Technical Service Bulletin

NUMBER: 18-019-00

Driveability Improvements

2000 (PL) Neon

Fig. 1 AUTHORIZED SOFTWARE UPDATE LABEL

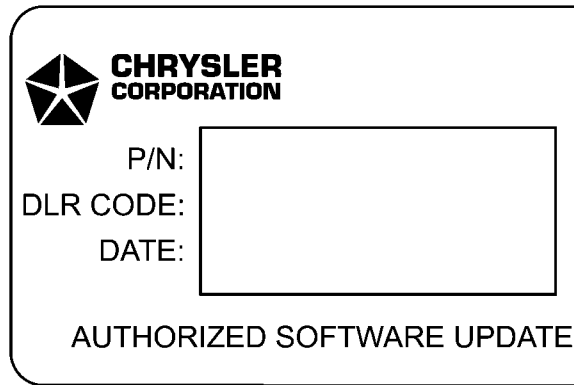
5. Select the new software part number with the light pen and click UPDATE CONTROLLER SOFTWARE.
6. The MDS2 and DRB III® will prompt for any operator action needed during the remainder of the reprogramming process.
7. Type the necessary information on the "authorized Software Update Label" p/n 04669020 (Fig. 1). Attach the label to the PCM and cover the label with the clear plastic overlay.

Fig. 2 AUTHORIZED MODIFICATION LABEL

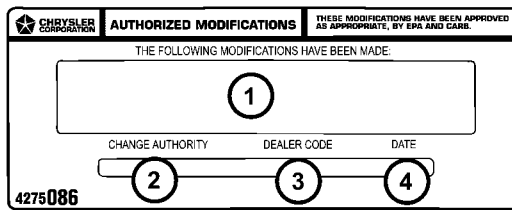
- 8. Type the necessary information on the “Authorized Modification Label” p/n 04275086 (Fig. 2) and attach the label near the VECI label.
